Proposal for amendments to Regulations Nos. 9, 41, 63 and 92

A. Regulation No.41 “Noise emissions of motorcycles”

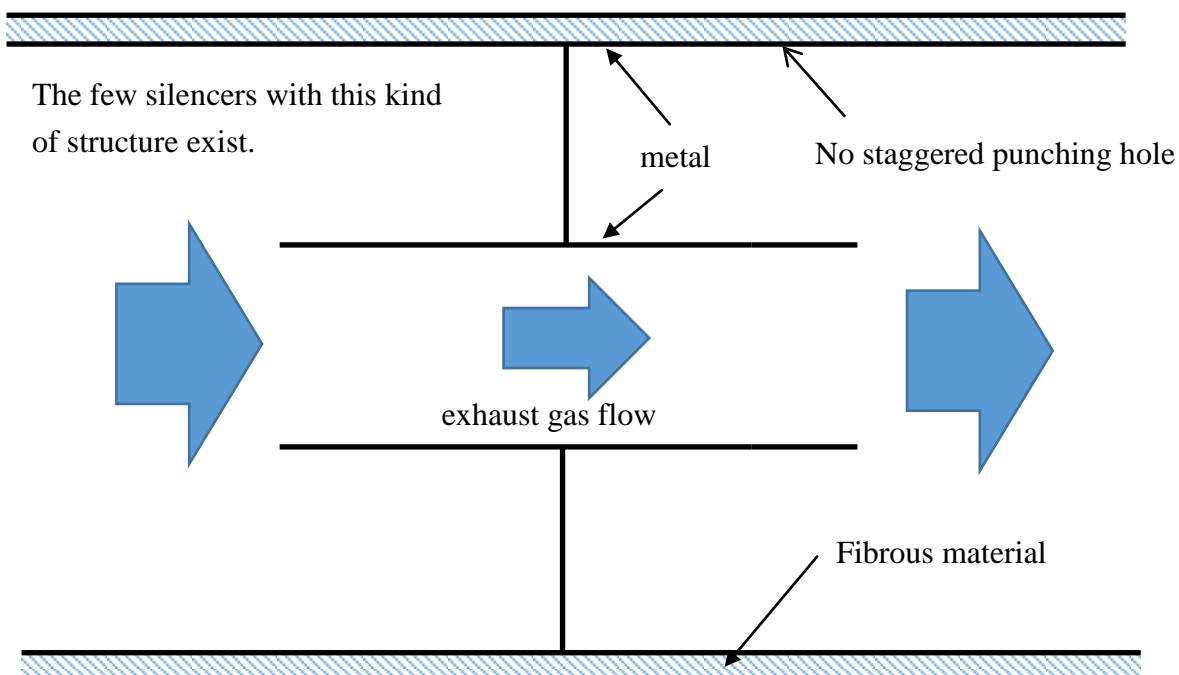
The structure in where the exhaust gas is not in contact with the fibrous material is as below figure. In this structure, the fibrous material is not at all in contact with exhaust gases (nor in direct contact, nor in contact through punching holes).

In this case, the fibrous materials are mainly used for the purpose of thermal insulation.
